DUKE POWER COMPANY
OCONEE NUCLEAR STATION
DOCKETS 50-269, -270, AND -287

SUPPLEMENT 1
TO
MDS REPORT NO. OS-73.2
ANALYSIS OF EFFECTS RESULTING FROM
POSTULATED PIPING BREAKS OUTSIDE CONTAINMENT
FOR
OCONEE NUCLEAR STATION, UNITS 1, 2, AND 3

The following information is voluntarily submitted in response to informal questions asked by the Division of Reactor Licensing during the June 12, 1973 meeting held in Bethesda, Maryland.

OCONEE NUCLEAR STATION
 MAIN STEAM SYSTEM
 LINE INTERACTION RESTRAINT
 (PRELIMINARY)
 FIGURE 4.2-1.b₂

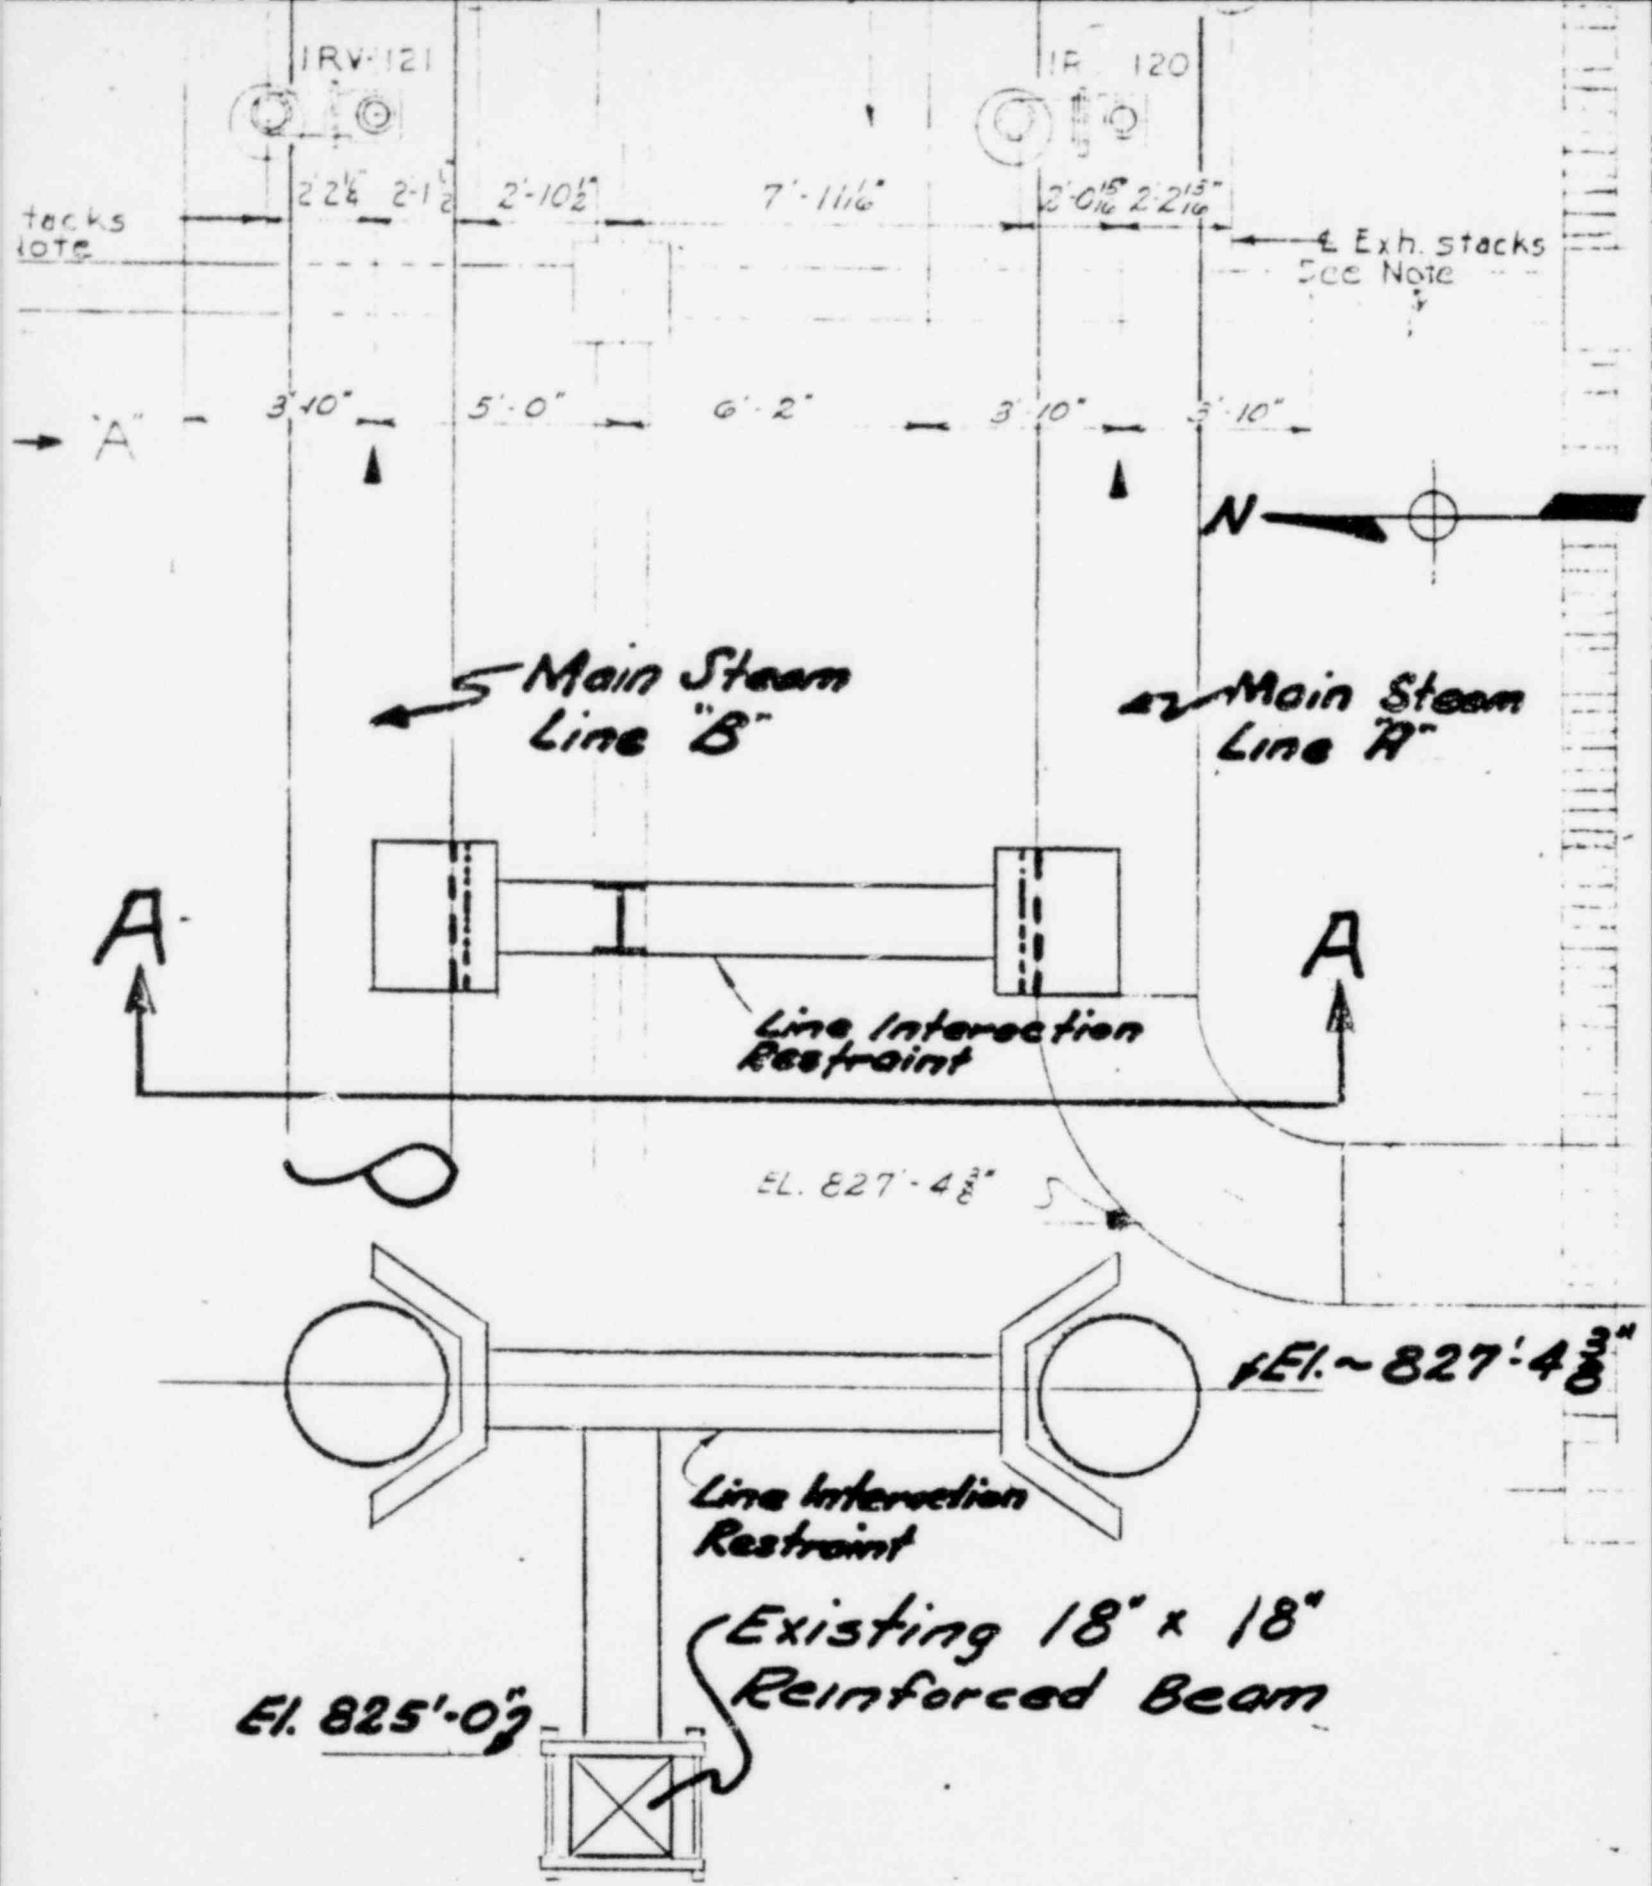
Describe the existing restraint system for the Main Steam lines and any proposed modifications.

Proposed modifications are to add a line interaction restraint between the two Main Steam lines immediately upstream of the Main Steam safety valves for the purpose of preventing a line break in Main Steam line B as a result of Main Steam line A terminal end break. The restraint will be designed to the following criteria:

1. Prevent Main Steam line A from interacting with Main Steam line B safety valves.
2. Normal thermal movements of either Main Steam line are not to be impaired
3. Mechanical loading and stress analysis aspects are:
 - a) All load bearing members will be designed to 0.9 yield stress for primary stresses.
 - b) A dynamic load factor of 3.0 will be used for applicable load bearing members of the restraint.

Figure 4.2-1.b₃ is a preliminary conceptual design of the proposed restraint.
